## Enable 2D Barcode for Legacy Components

PCN: 33455

**Type:** Product Mark/label Change

### SOP2/W-PDFN/BGA/LGA Abbreviated Component Mark

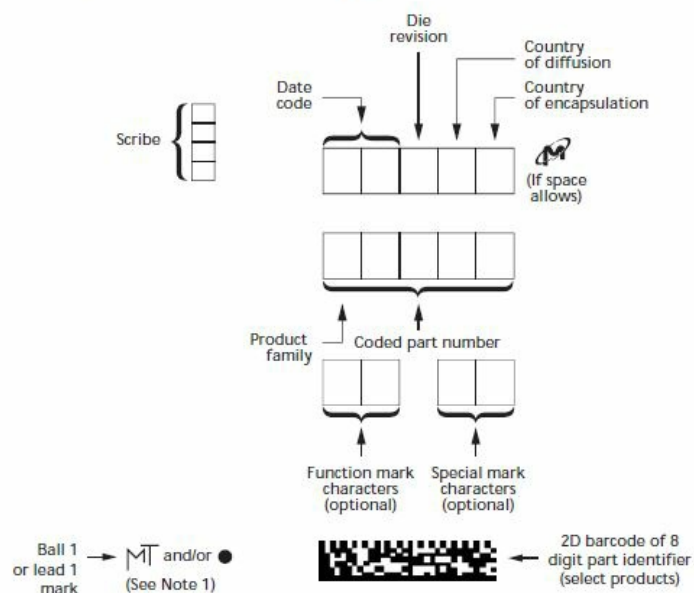
**Description:** For improved unit-level traceability, Micron is enabling 2D barcode on the component mark for the following legacy components including the component's respective module/SSD. Please refer to page 6 in CSN-11: Product Marks/Product and Packaging Labels for component marking details.

The internal conversion will start from February 2020 and complete by August 2020. Customers may receive mixed shipments with and without 2D barcode during the conversion period.
